UR Universal Relay Series

Revision 5.00 release note

GE Publication Number: GER-4078

This document contains the release notes for the 5.00 release of the UR Universal Relay series.

N Time offsets: time offsets (time zone and daylight savings time) added to relays

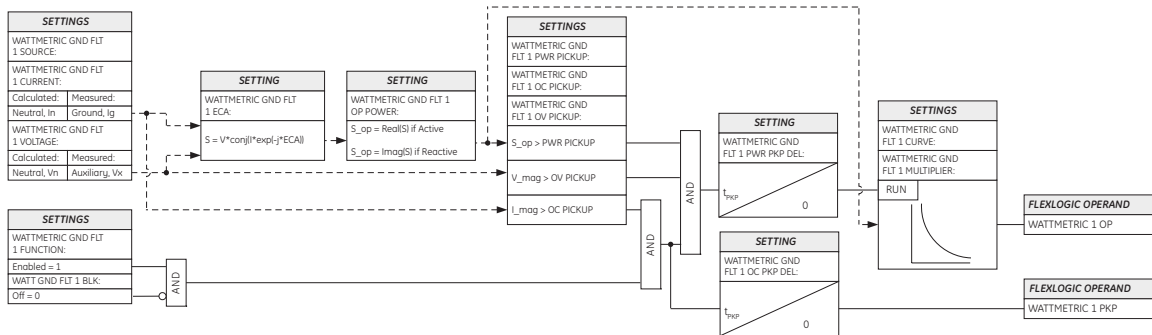
The 5.00 release introduces new settings and functionality to allows UR-series relays to determine their local time offset from Universal Time (UTC). The SNTP protocol provides UTC time synchronization. The new time zone and daylight savings time (DST) settings allow the relay to offset its clock to its own local time.

The IRIG-B function provides local time. When IRIG-B is in use, the DST settings are ignored.

The time zone offset setting and UTC time are used to calculate the IEC 61850 protocol timestamps, which are required to be UTC.
